The Official Gazette
(EXTRAORDINARY)
OF GUYANA

B. **SUBSIDIARY LEGISLATION —** Requirement No. 5 of 2026 Civil Aviation (Amendment) Requirements for Certified Aerodromes 2026. … … … … 775

GUYANA No. 5 of 2026

Citation. These Requirements, which amend the Civil Aviation Requirements for Certified Aerodromes 2024 may be cited as Civil Aviation (Amendment) Requirements for Certified Aerodromes 2026.

Figure 5-11 Protected flight zones

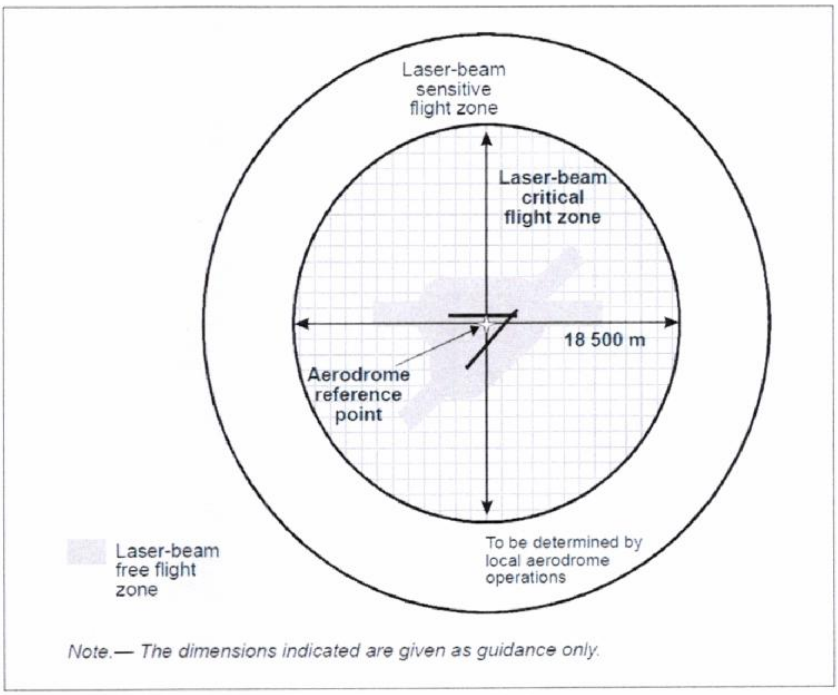
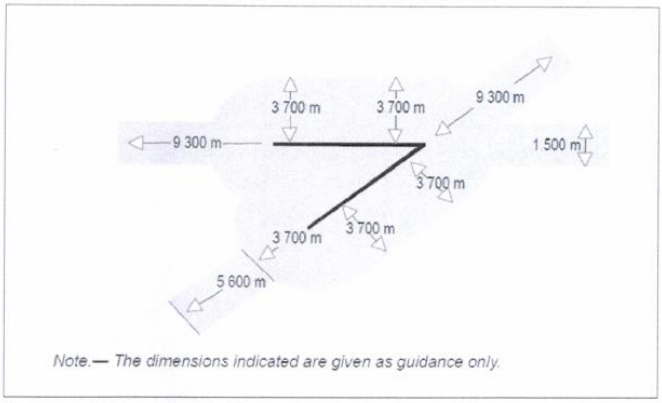
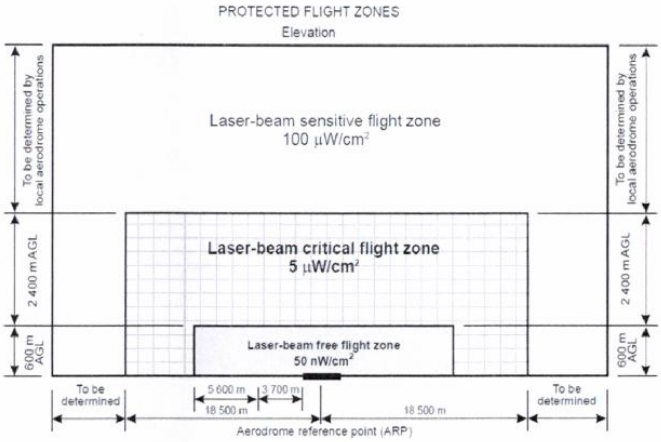
Insert as new paragraph **5.3.1.1 (a)**, the following –

To protect the safety of aircraft against the hazardous effects of laser emitters, thefollowing protected zones shall be established around aerodromes:

— a laser-beam free flight zone (LFFZ)
— a laser-beam critical flight zone (LCFZ)
— a laser-beam sensitive flight zone (LSFZ).

Note 1.— Figures 5-11, 5-12 and 5-13 may be used to determine the exposure levels and distances that adequately protect flight operations.

Replace **Figure 5-15. Inner 300 m approach and runway lighting for precision approach runways, categories II and III, where the serviceability levels of the lights specified as maintenance objectives in Chapter 10 can be demonstrated** with the following:

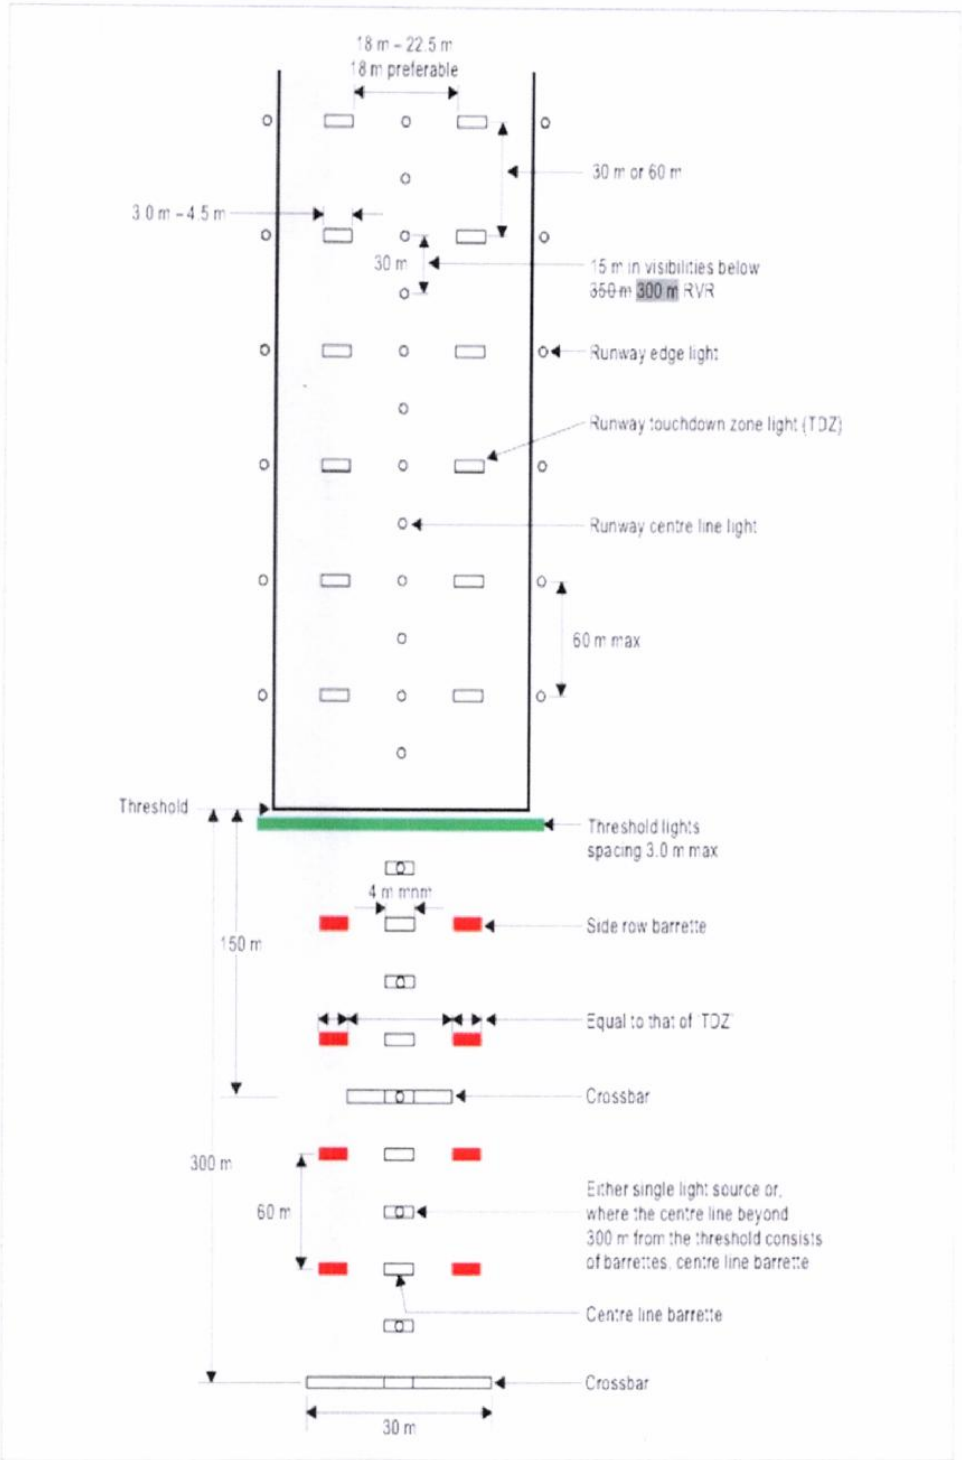
Paragraph 5.3.4.27

Figure 7-2. Example of equivalent elevated closed runway lighting with five lights per branch.

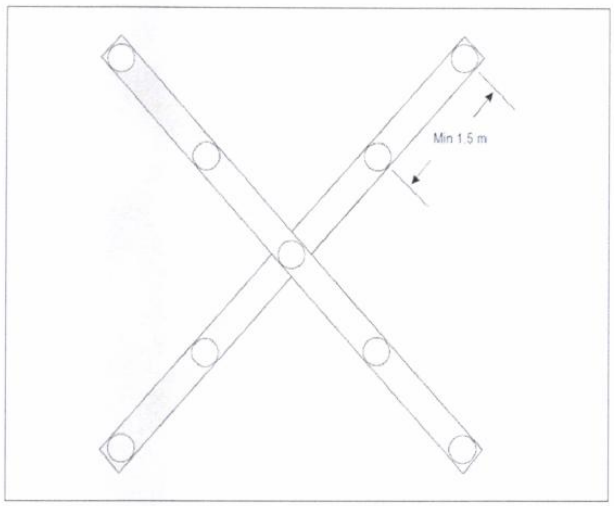
7.1.4.3 The closed runway lighting as viewed by the pilot shall be of the equivalent elevated form and proportions as detailed in Figure 7-2, showing a minimum of five lights uniformly spaced on each branch, with a minimum interval as specified by Table 7-1.

Figure 7-3. Examples of unserviceability signs

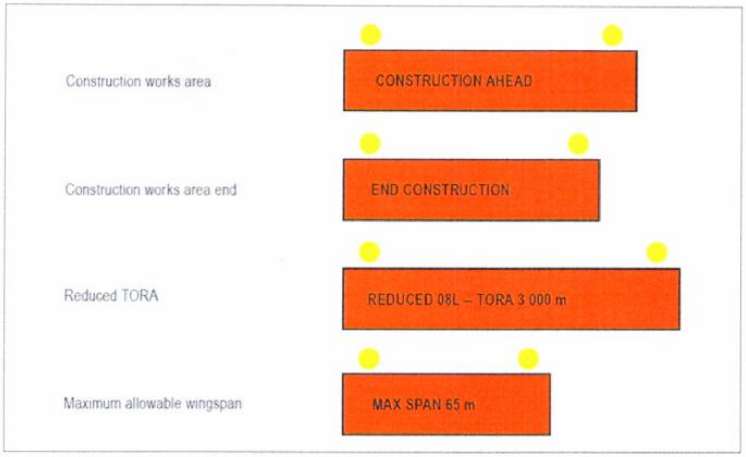
7.4.3.8 Unserviceability signs shall be rectangular, as shown in Figure 7-3, with the longer side horizontal.

7.4.3.10 Unserviceability signs shall consist of an inscription in black on an orange background. Unserviceability signs shall be supplemented by a black outline measuring 10 mm in width for runways where the code number is 1 or 2, and 20 mm in width for runways where the code number is 3 or 4.

Figure A2-26. Isocandela diagram for closed runway lights (white light)

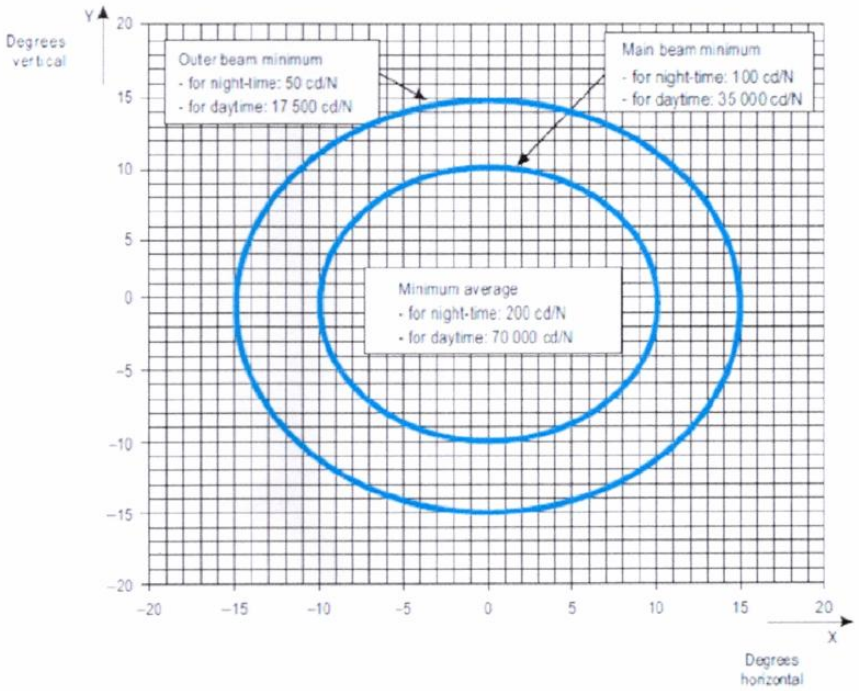
20. Immediately after figure A2-25 insert the following –

1. Curves calculated on formula $(x^2/a^2)+(y^2/b^2) = 1$

2. N is the total number of lights of the closed runway lighting.

Figure A4-5. Sign dimensions for RDRS

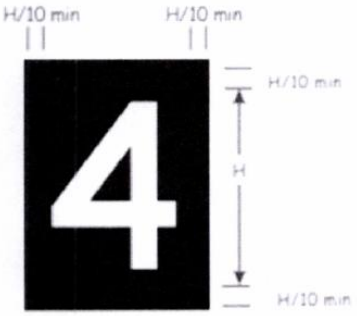
"12. The face width of runway distance remaining sign (RDRS) shall be determined using Figure A4-5."

6. Immediately after figure A4-4, insert the following –

Figure A-10. Runway distance remaining sign configurations"

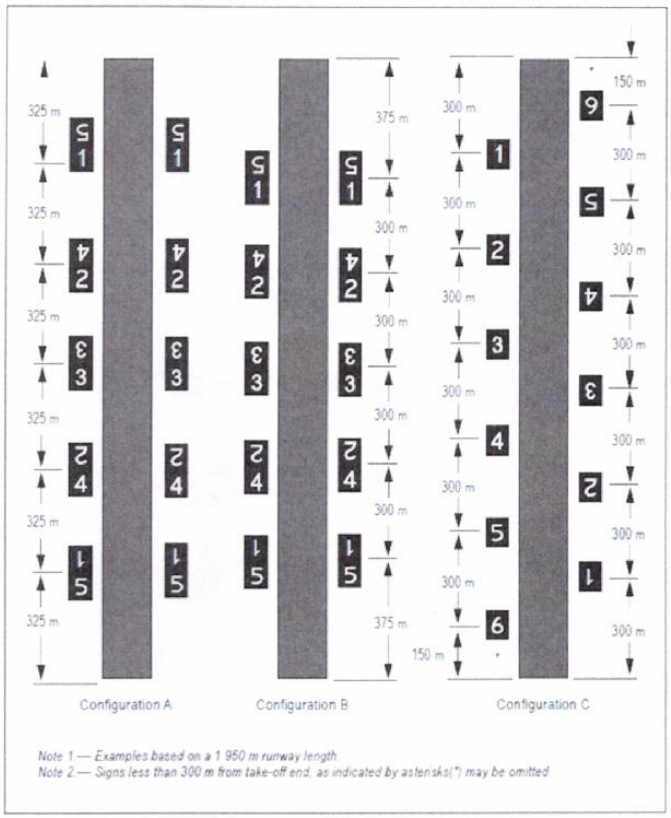
Attachment A 1. Immediately after paragraph 22.3, insert the following –

23.2 RDRSs are placed along the full length of the runway at longitudinal spacing of 300 m (±30 m), parallel and equidistant from the runway centre line as in Configurations A, B or C, illustrated in Figure A-10. RDRSs are arranged by any of three different configurations as shown in Figure A-10.
